HISTORIC AND DESIGN REVIEW COMMISSION

June 05, 2019

HDRC CASE NO: 2019-301
ADDRESS: 1939 W GRAMERCY PLACE
LEGAL DESCRIPTION: NCB 1931 BLK 38 LOT 10
ZONING: R-6, H
CITY COUNCIL DIST.: 7
DISTRICT: Monticello Park Historic District
APPLICANT: Bruce Graham/GRAHAM BRUCE
OWNER: Bruce Graham/GRAHAM BRUCE
TYPE OF WORK: Window replacement
APPLICATION RECEIVED: May 01, 2019
60-DAY REVIEW: June 30, 2019
CASE MANAGER: Huy Pham

Proposal #1

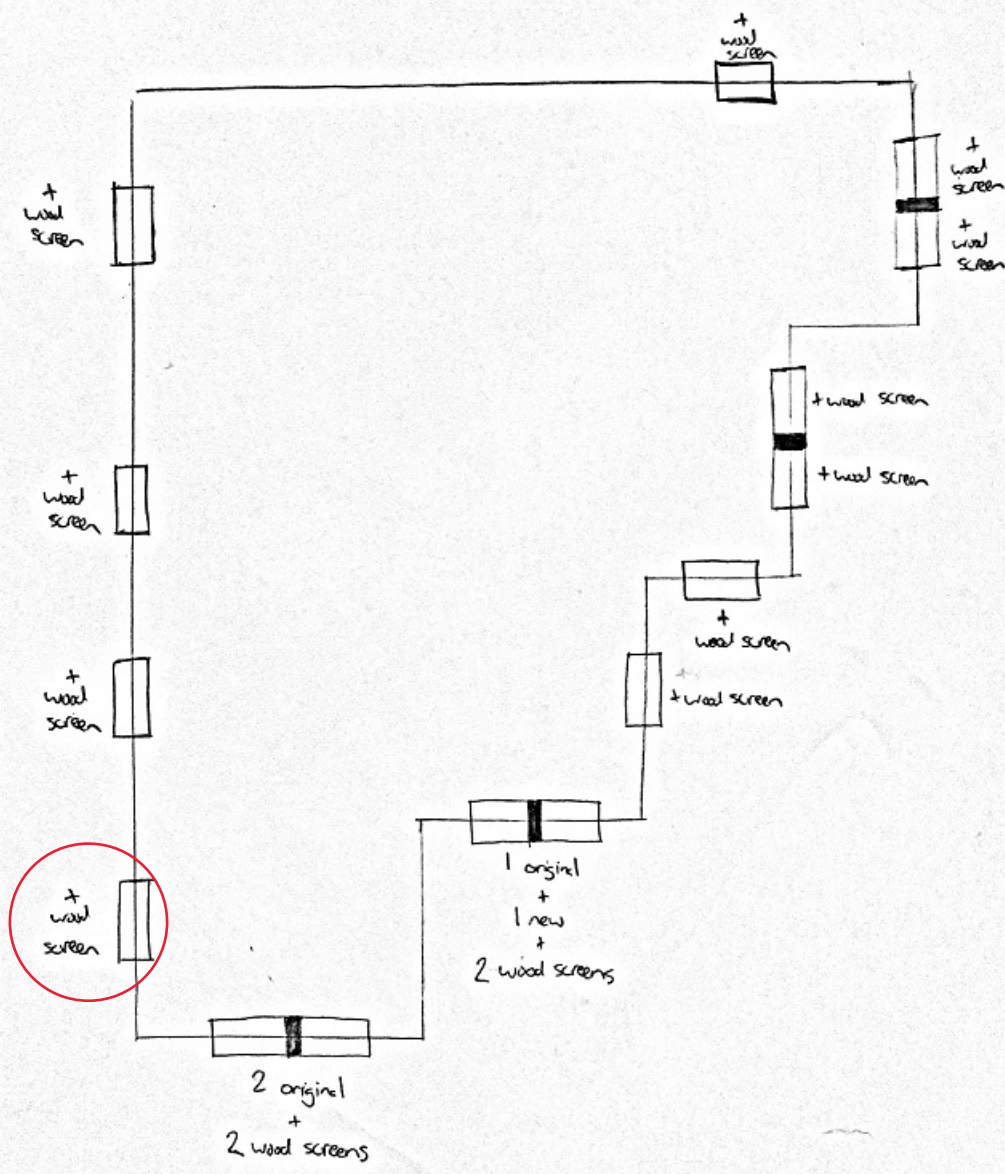
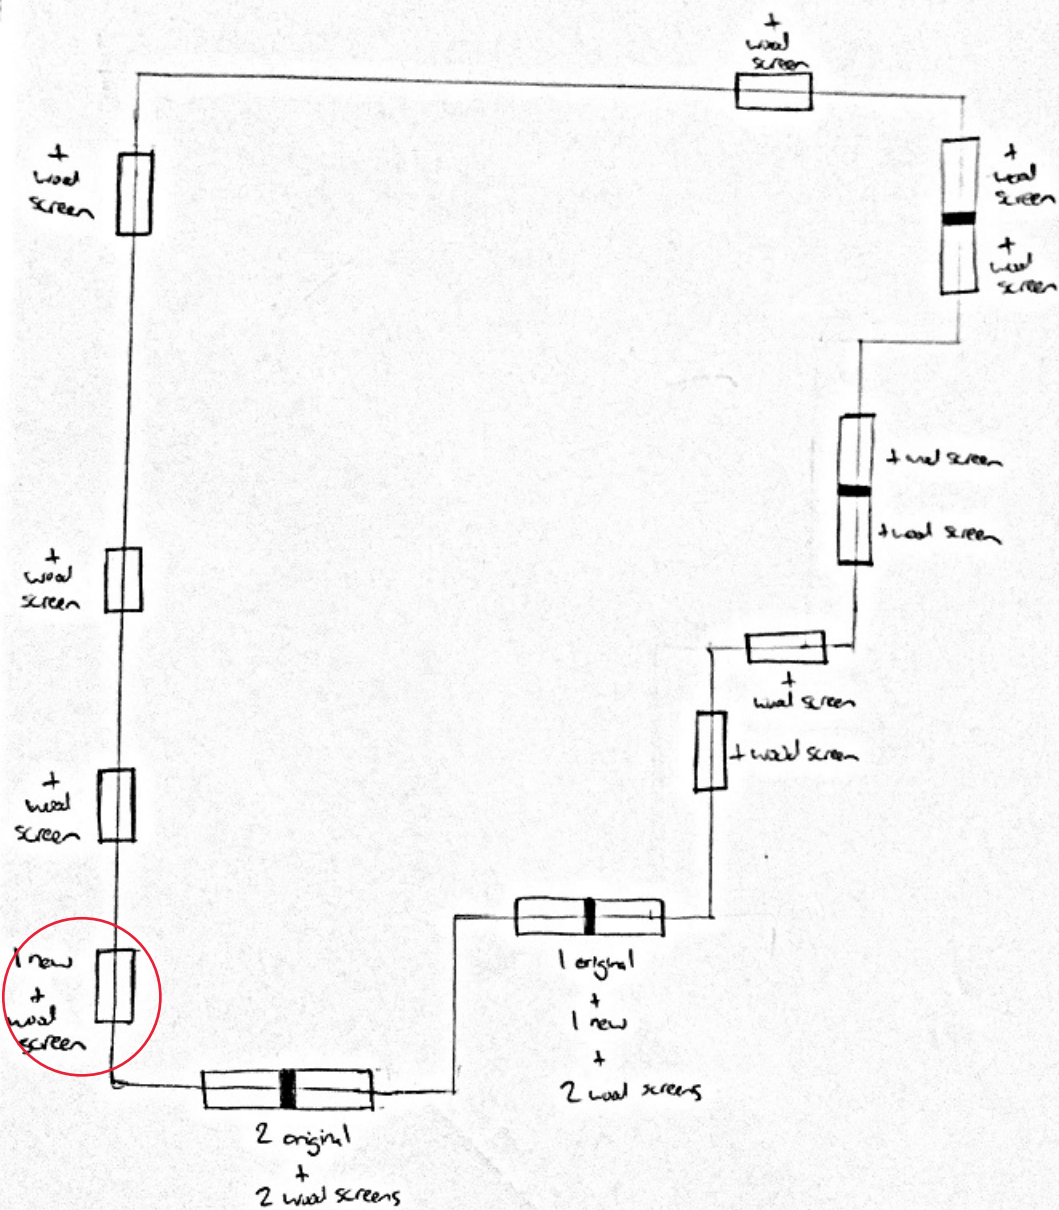
- e. WINDOW REPLACEMENT – The has applicant proposed two options, one featuring five wood (5) windows and the other with four (4) wood windows -- while the remaining ten or eleven (10 or 11) windows would be vinyl replacements. The Guidelines for Exterior Maintenance and Alterations 6.B.iv. notes that window replacement should only be considered when the original windows are deteriorated beyond repair. At the time of the site visit in August 2018, staff found that the windows that were still on site were in a repairable condition. Staff finds that the applicant should repair the existing windows. Staff finds that the applicant should only replace should replace windows where they have been determined to be deteriorated beyond repair. Replacement windows should be comparable to the original wood windows in regards to materials and profile.

- f. NEW WINDOWS – The applicant has proposed to install white, one-over-over vinyl windows to replace up to eleven (11) wood windows. The Guidelines for Architectural Features 6.B.iv. notes that new windows are to match the historic or existing windows in terms of. Staff finds that the proposed windows are not compatible in style or materials with the original windows. Staff finds that replacement windows should match the original wood windows in size, type, configuration, material, form, appearance, and details including the standard stipulations: *Meeting rails that are no taller than 1.25" and stiles no wider than 2.25". White manufacturer's color is not allowed, and color selection must be presented to staff. There should be a minimum of two inches in depth between the front face of the window trim and the front face of the top window sash. This must be accomplished by recessing the window sufficiently within the opening or with the installation of additional window trim to add thickness. Window trim must feature traditional dimensions and an architecturally appropriate sill detail. Window track components must be painted to match the window trim or concealed by a wood window screen set within the opening.*

- i. Staff recommends approval of item 1 (three repaired and two reconstructed wood windows on the front facade) with the stipulation that specifications for an appropriate reconstruction and installation are submitted to staff prior to the issuance of a Certificate of Appropriateness.

- ii. Staff does not recommend approval of item 2 (ten wood windows replaced with vinyl on the side and rear facades). If the remaining windows have been permanently discarded or are deteriorated beyond repair, replacement windows should match the original wood windows in size, type, configuration, material, form, appearance, and should meet the following specifications: *Meeting rails must be no taller than 1.25" and stiles no wider than 2.25". White manufacturer's color is not allowed, and color selection must be presented to staff. There should be a minimum of two inches in depth between the front face of the window trim and the front face of the top window sash. This must be accomplished by recessing the window sufficiently within the opening or with the installation of additional window trim to add thickness. Window trim must feature traditional dimensions and an architecturally appropriate sill detail. Window track components must be painted to match the window trim or concealed by a wood window screen set within the opening.*
